CITY OF GEARHART

APPLICATION BEFORE THE CITY OF GEARHART PLANNING COMMISSION

Re: Two-lot Partition on Hillila Road

CITY OF GEARHART PLANNING COMMISSION

18x24

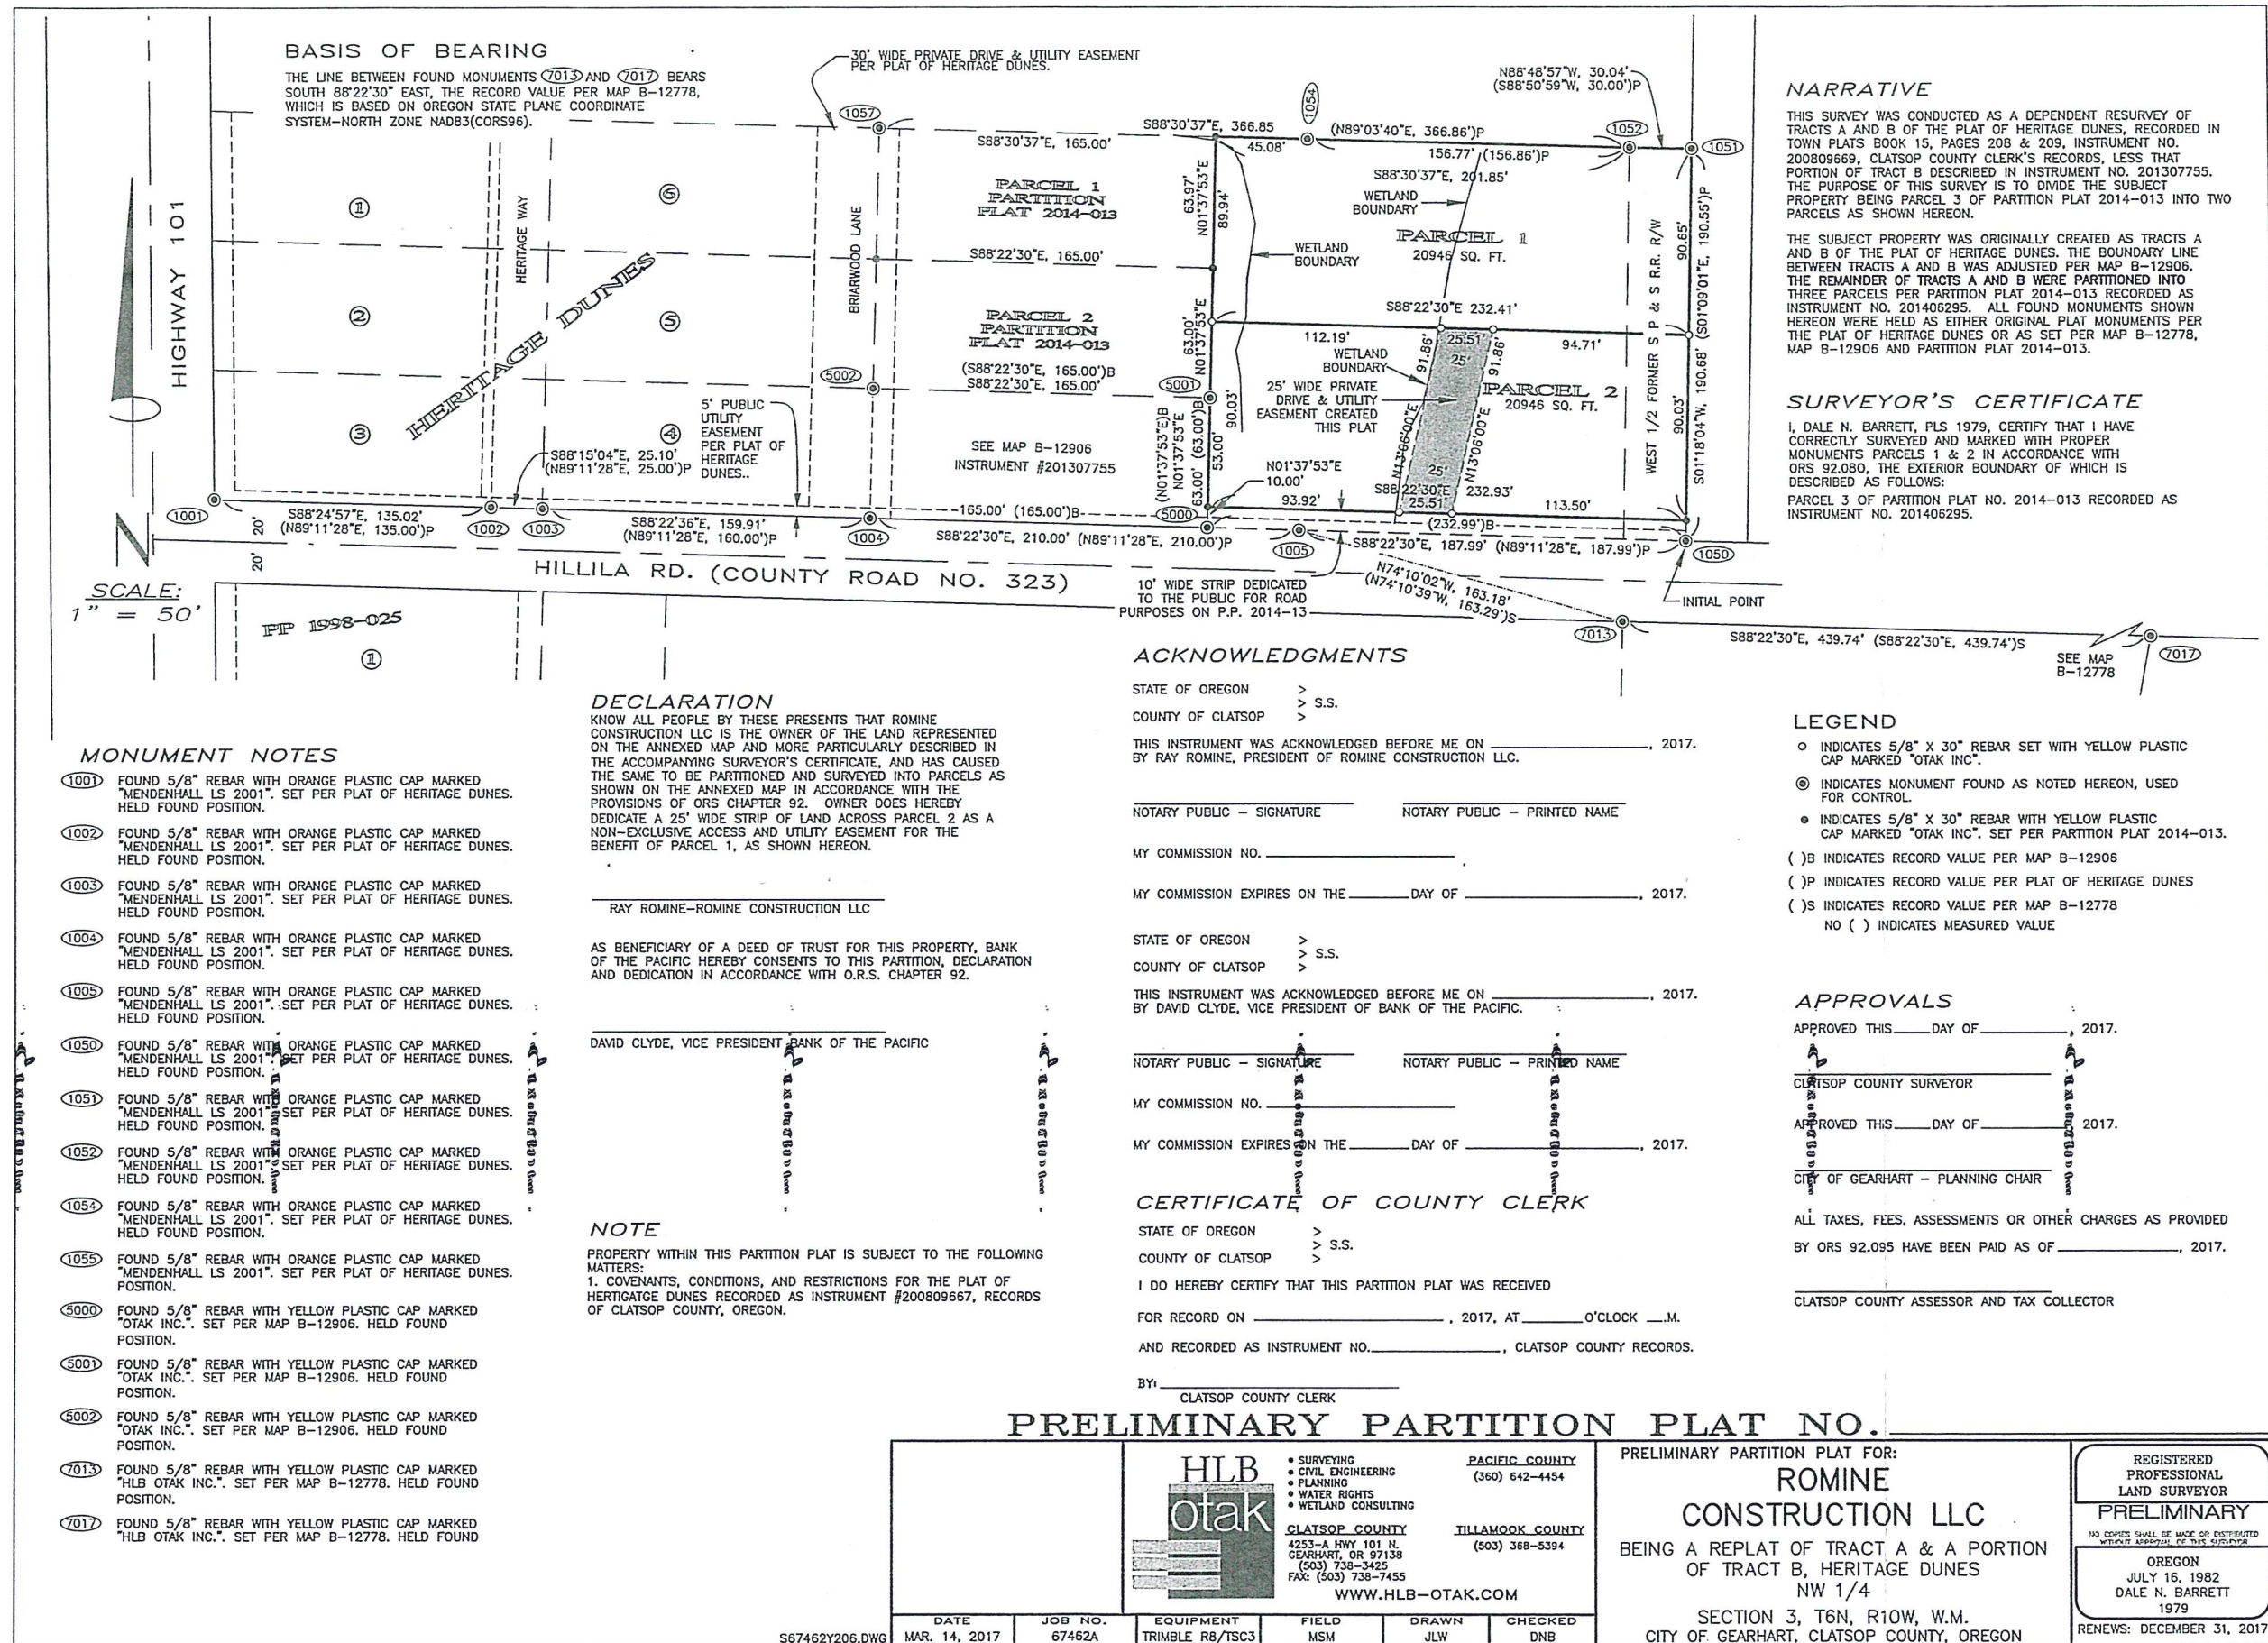
Romine: I have read the Fire Chiefs comments regarding this Partition and agree with it entirely. It is crucial for Romine to show how the fire apparatus access road, turnaround (if required), hydrant location and water supply will be met.

The "Preliminary Partition" attached does not show any Fire Department features (road widths, apparatus turnarounds measurements, hydrant locations, etc.), these requirements need to be approved by the Fire Chief prior to approval of this development. From the existing hydrant to the proposed "2nd lot" the distance measures approximately 625 to 650 feet as measured in an approved route around the exterior of the structure(s). (OFC 507.5.1).

2. Prior to issuance of a building permit on Parcel 1, in accordance with Gearhart Fire Department letter dated July 11, 2017,
 - Driveway Access improvement: The applicant shall provide documentation from a registered engineer that the finished construction of the road is in accordance with the OFC Road Standards. This includes an improved surface of no less than 14 feet wide; if the driveway is greater than 150 feet from Hillila Road an area to safely turnaround a fire department apparatus may be required per OFC 503.1.1.

- Signage: The applicant shall install a “NO PARKING – FIRE LANE” sign on both sides of the access easement, unless the driveway width provides for on-street parking.
